**CITY OF BLOOMINGTON  
PLAN COMMISSION  
April 13, 2015 @ 5:30 p.m.**

**BLOOMINGTON PLAN COMMISSION**  
**STAFF REPORT – 2<sup>nd</sup> Hearing**  
**Location: 2894 E. 3<sup>rd</sup> Street**

**CASE #: PUD-05-15**  
**DATE: April 13, 2015**

**Date:** April 13, 2015  
**To:** Bloomington Plan Commission  
**From:** Bloomington Environmental Commission  
**Through:** Linda Thompson, Senior Environmental Planner  
**Subject:** PUD-5-15 Simon Property Group, College Mall, second hearing  
2894 E. 3<sup>rd</sup> Street

PUD-05-15  
Whole Foods West  
Elevation

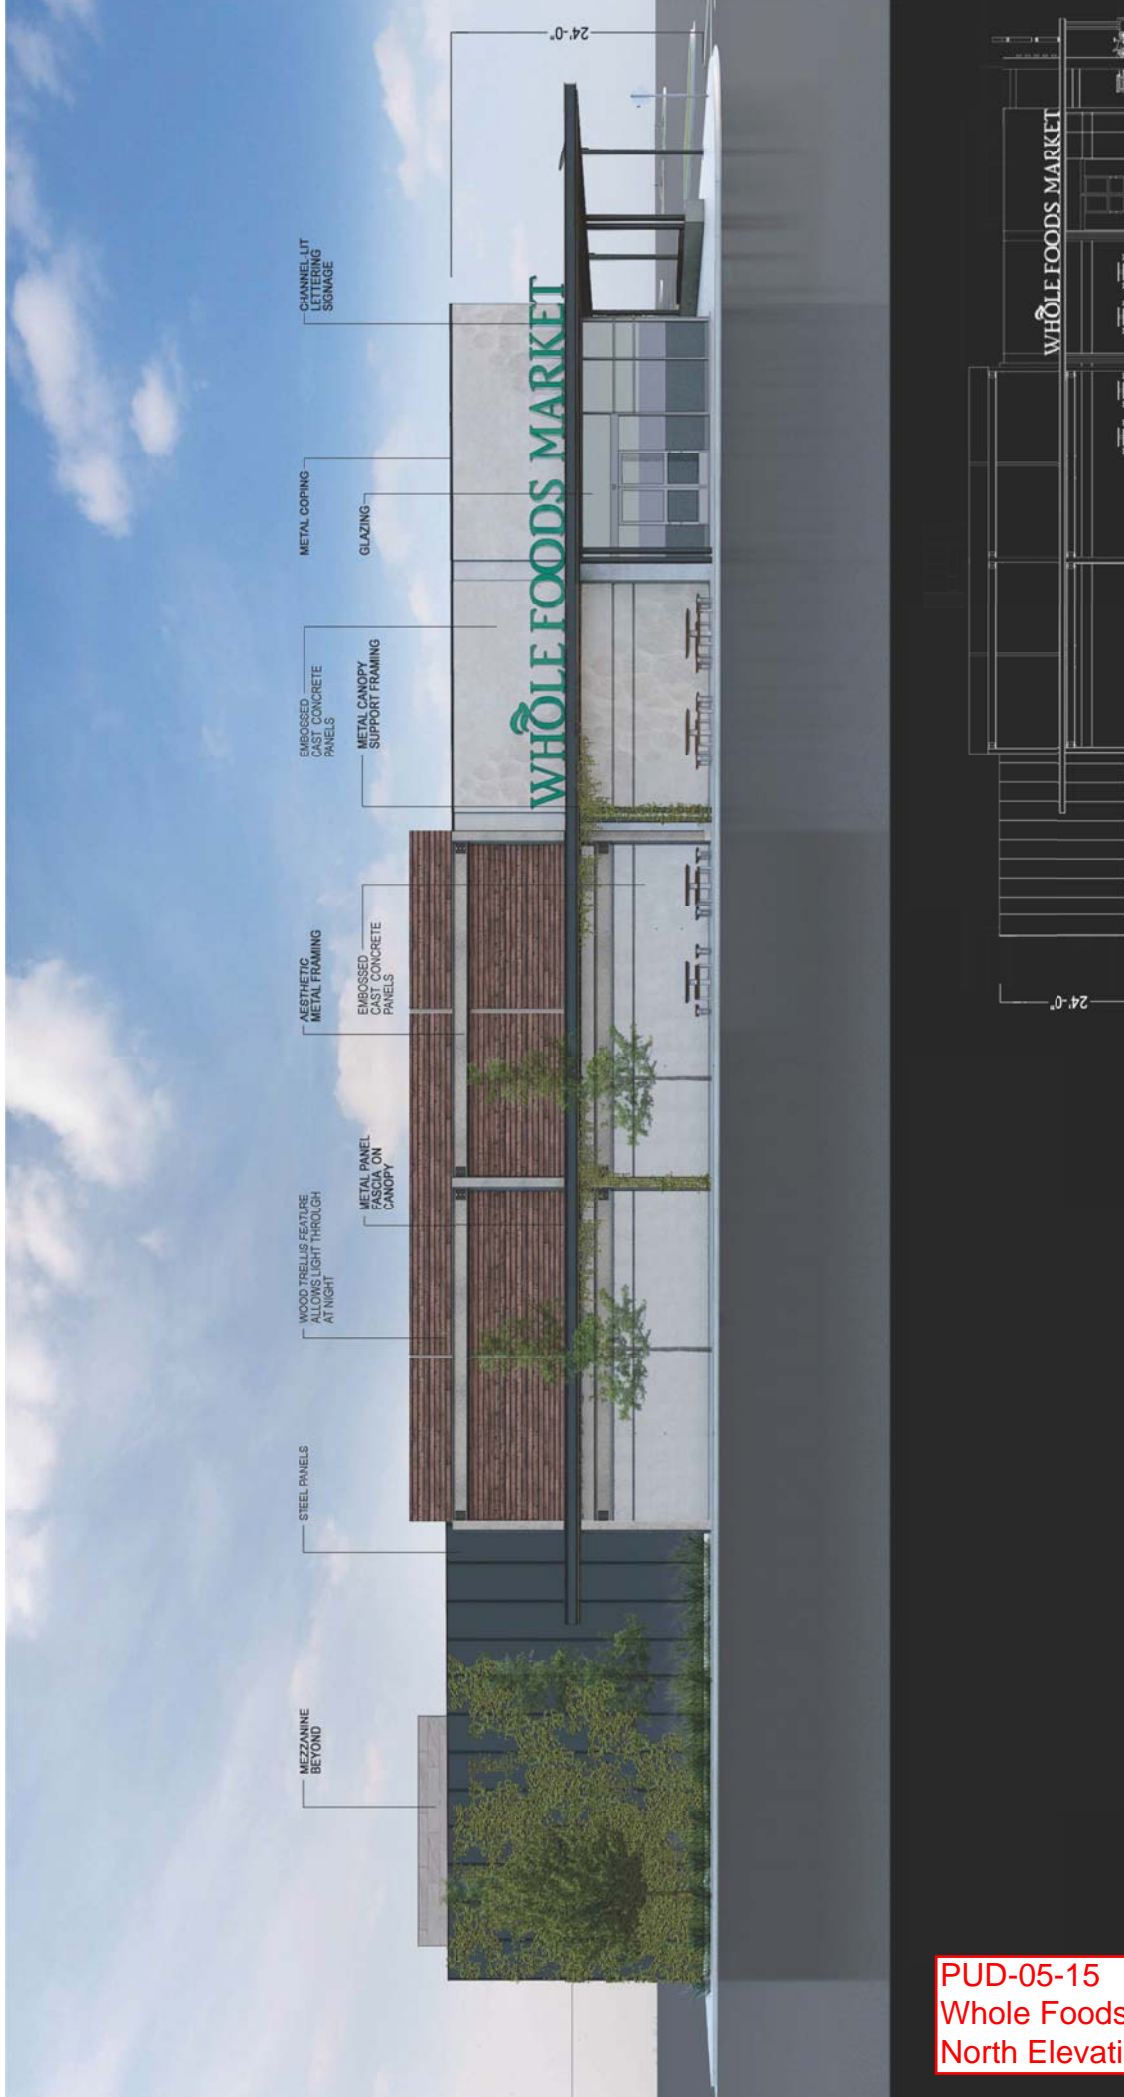
**Whole Foods:** The petitioner has submitted revised elevations for the north façade based on the Plan Commission comments. The 31,000 sq. ft. Whole Foods will use precast concrete and wood cladding for the west and north façades with glass storefront along the west side that wraps around to the north façade. The revised north elevation shows a substantial reduction in the amount of metal siding from what was previously shown with wood cladding extending along the façade with embossed cast concrete panels along the lower sections

PUD-08-15  
ASFR typical  
landscape plan

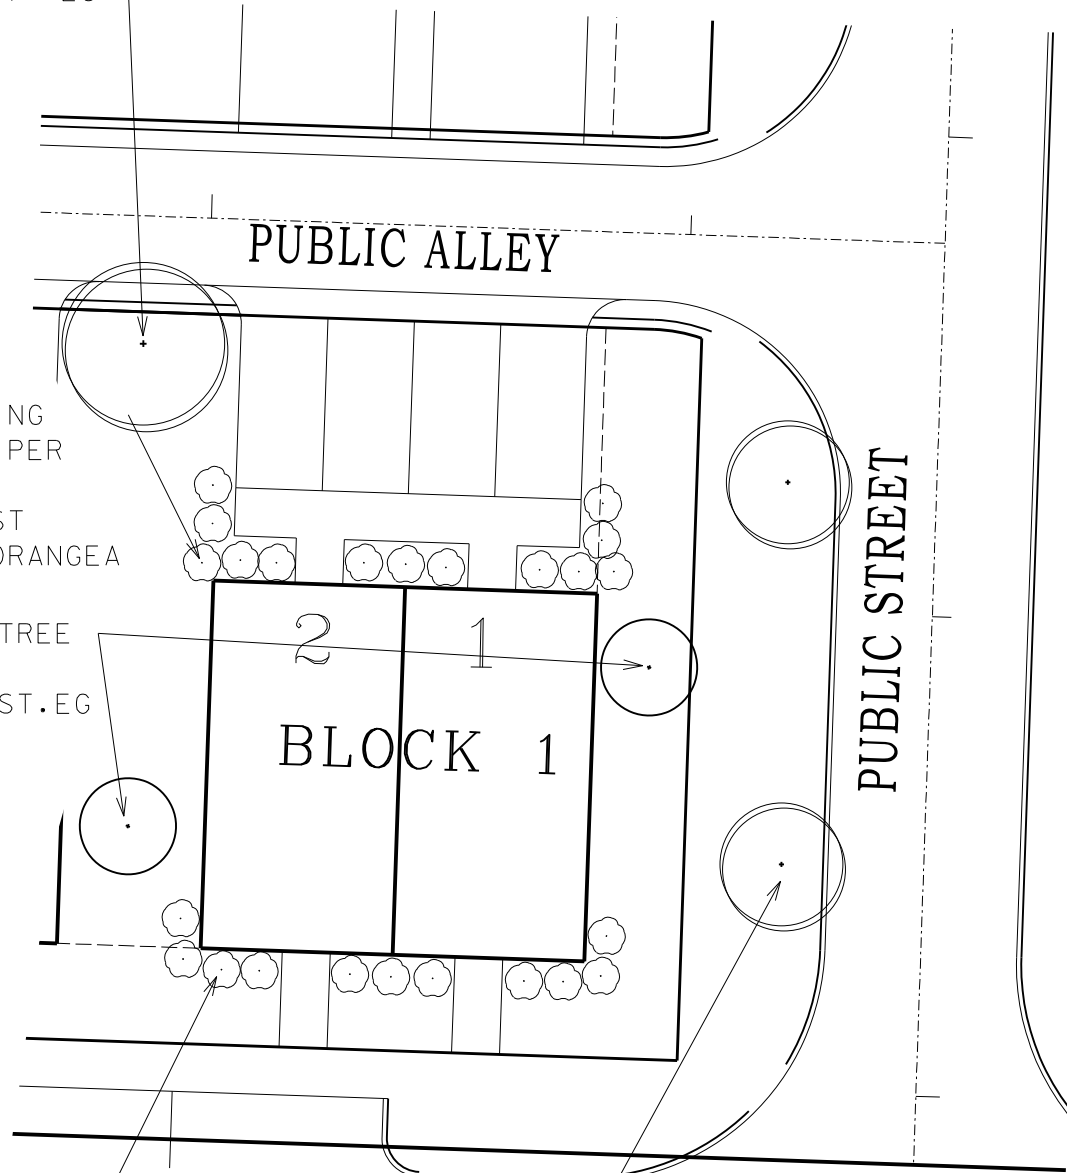
The Landscape Plan submitted shows that some street trees are missing. The requirement dictates that street trees shall be planted between twenty (20) and forty (40) feet apart, calculated at one (1) canopy tree per every forty (40) feet of property that abuts a public right-of-way.

**Staff response:** Staff will continue to work with the petitioner to insure the required number of street trees are installed.
